RE: Permissive change to model id:MMAGXT950

These changes are now made to the GXT950 to make the new models GXT1000 and GXT1050:

old mic ckt

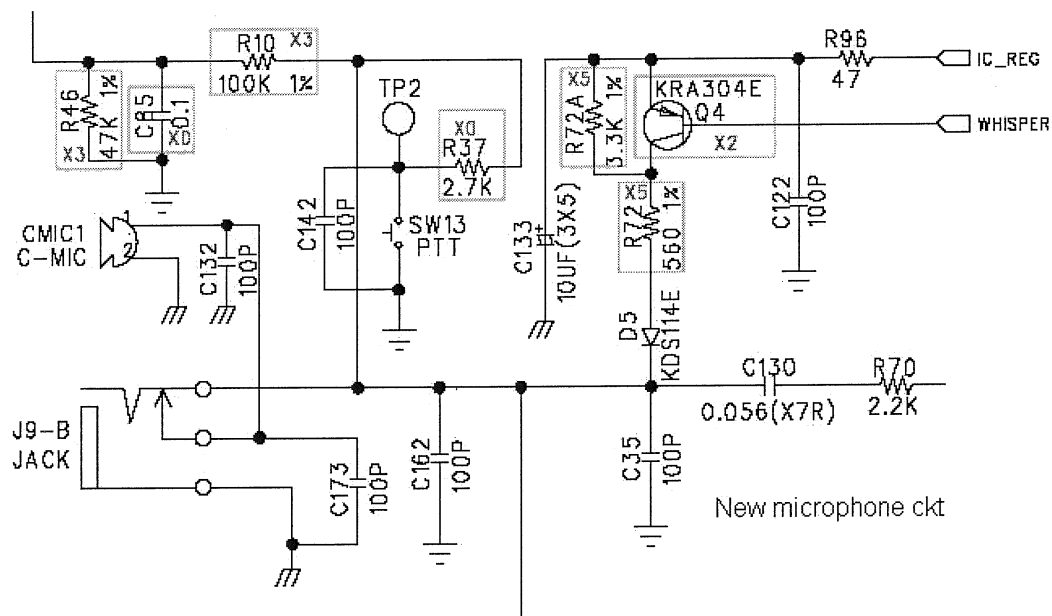
Transmitter driver stage change for reason of economy:

GXT900/950 driver stage is composed 3pcs of BFQ67W (Q3,Q4, Q4A), while GXT1000/1050 driver stage is using 1 RF Amp NESG250134.
